CENTRAL LATHROP

DESIGN GUIDELINES
AND MASTER SIGNAGE PLAN

CENTRAL LATHROP DESIGN GUIDELINES AND MASTER SIGN PLAN ERRATA

The following amendments have been made to the Central Lathrop Design Guidelines and Master Sign Plan, dated November 9, 2004.

Figure 3-26: Primary Community Gateway Plan and Elevation

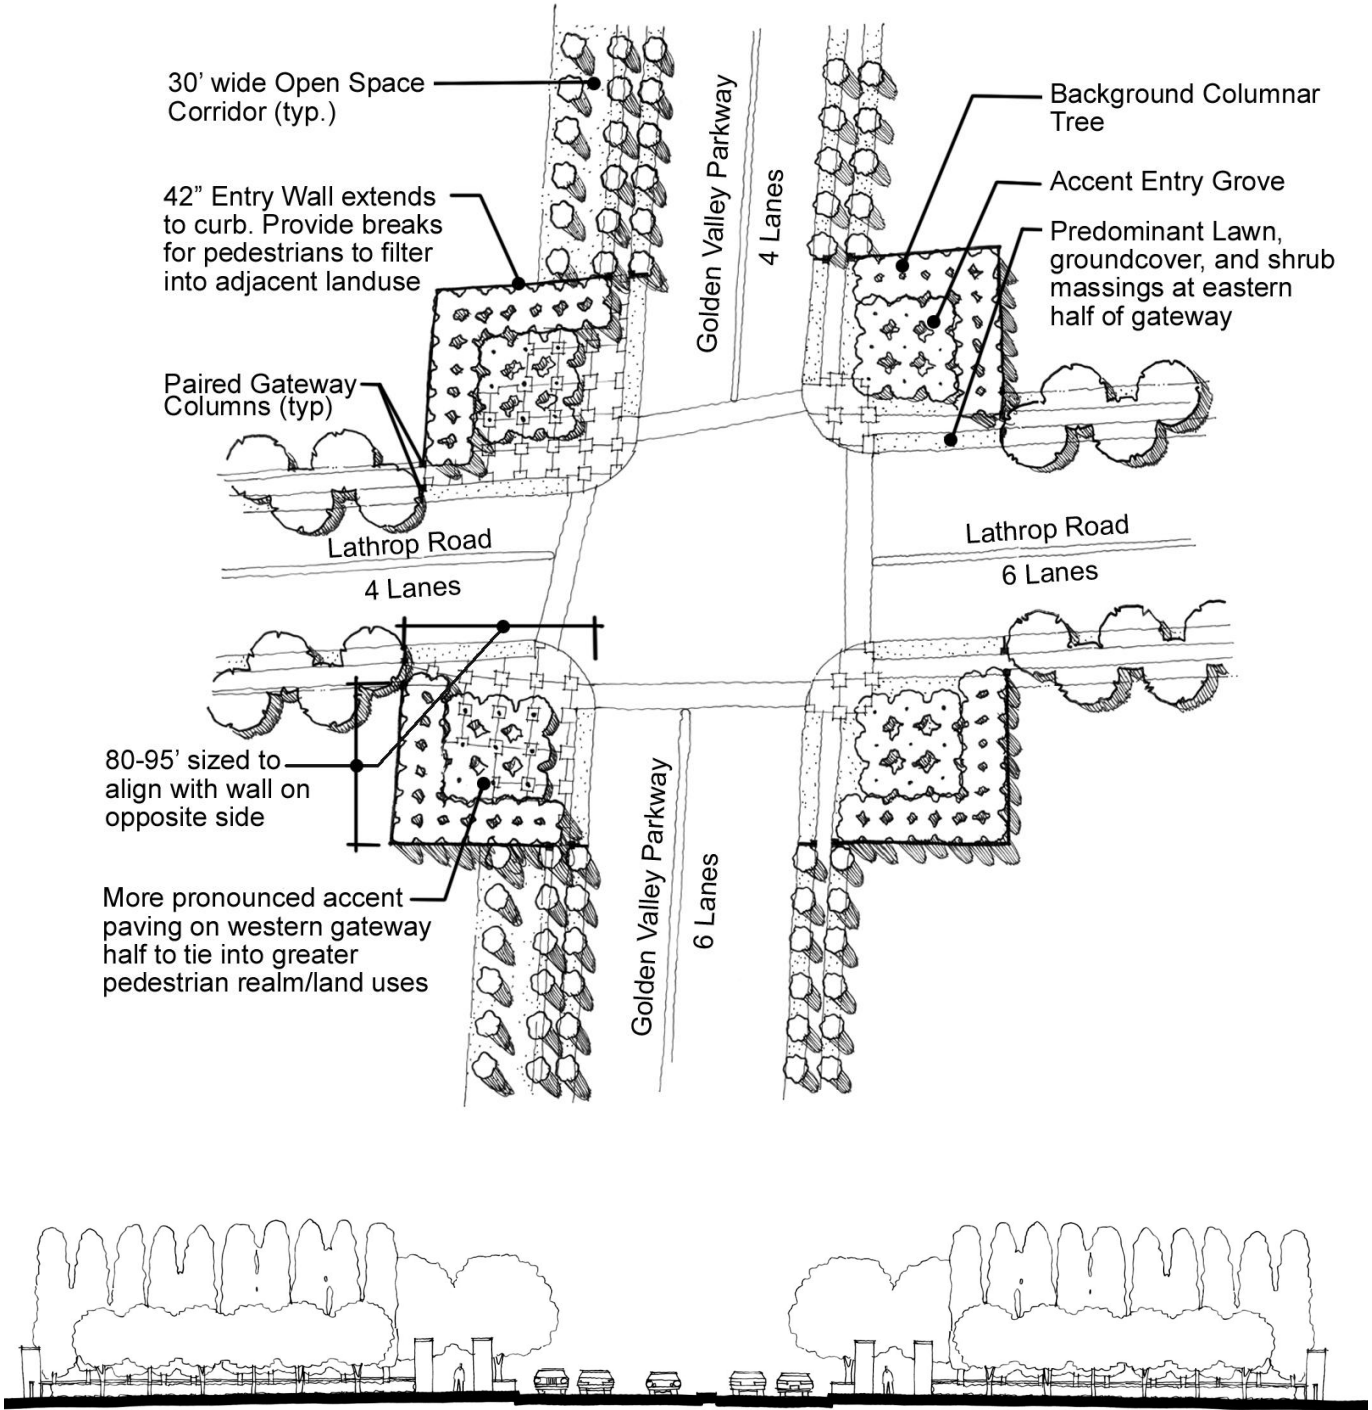
3-52	Section 3.3.1: Community Gateways. A. Primary Community Gateway. Revise text to allow the square footage to exceed twelve (12) square feet if reviewed and approved by the CLDRB.

Figure 3-27: Secondary Community Gateway Plan

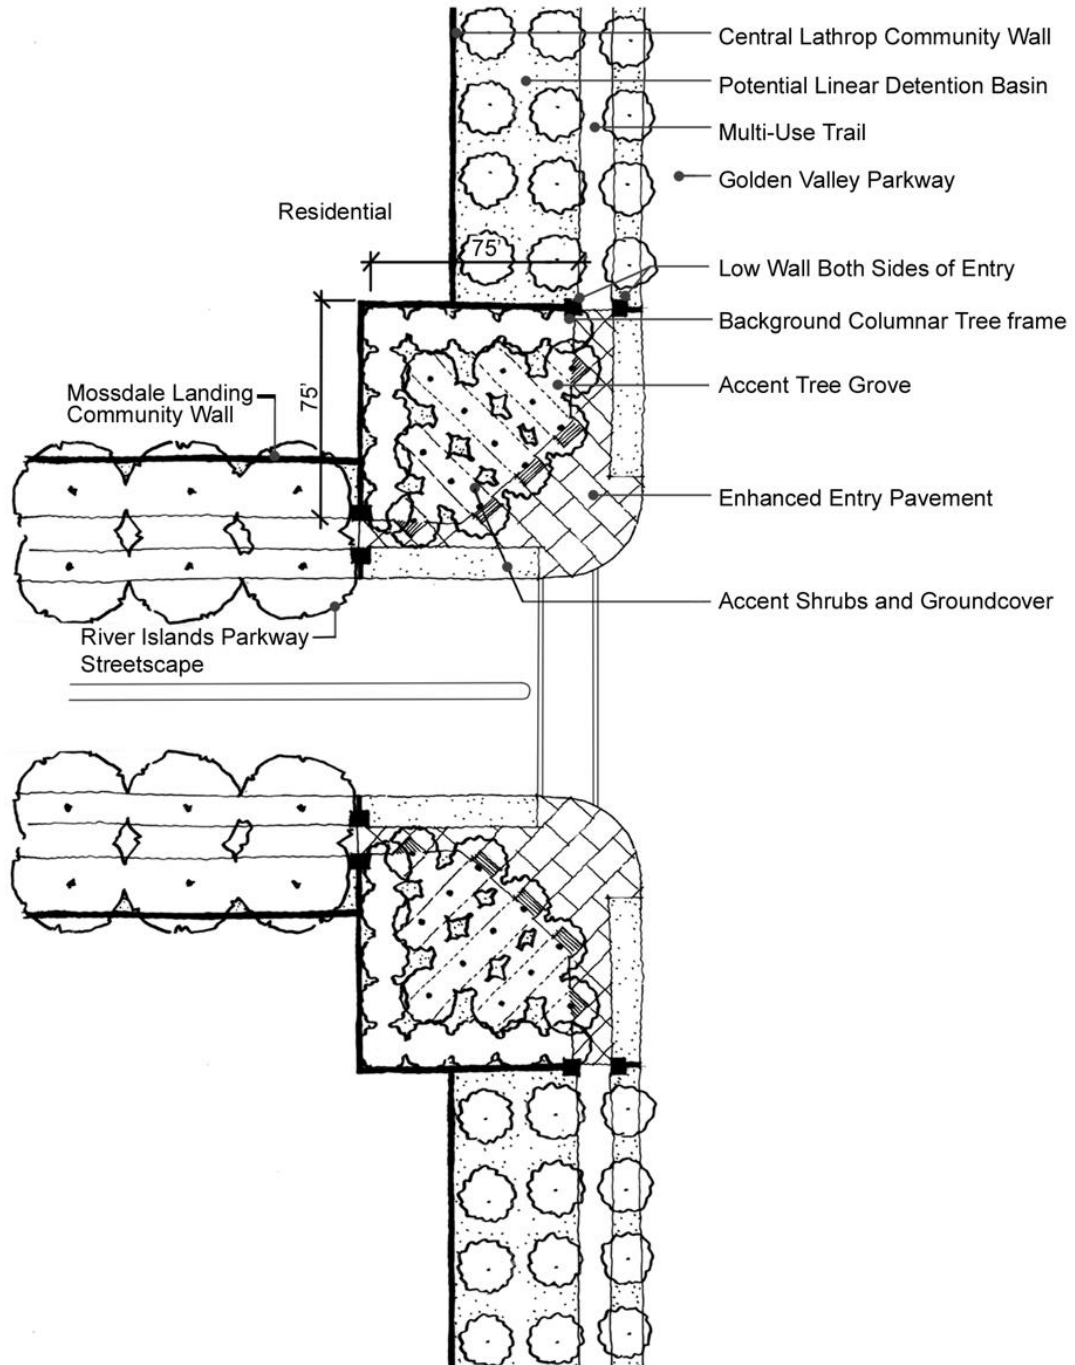
<u>Section</u>	<u>Date</u>	<u>Page Reference</u>	<u>Comment</u>
I.	Substantial Conformance Approval, dated April 13, 2020.	3-54	Section 3.3.1: Community Gateways. B. Secondary Community Gateway. Revise text to allow the square footage to exceed twelve (12) square feet if reviewed and approved by the CLDRB.
		5-4	5.4.1: Primary Community Gateway Signs. Add text to No. 1 to allow the square footage to exceed twelve (12) square feet if reviewed and approved by the CLDRB.
		5-5	5.4.1: Secondary Community Gateway Signs. Add text to No. 1 to allow the square footage to exceed twelve (12) square feet if reviewed and approved by the CLDRB.
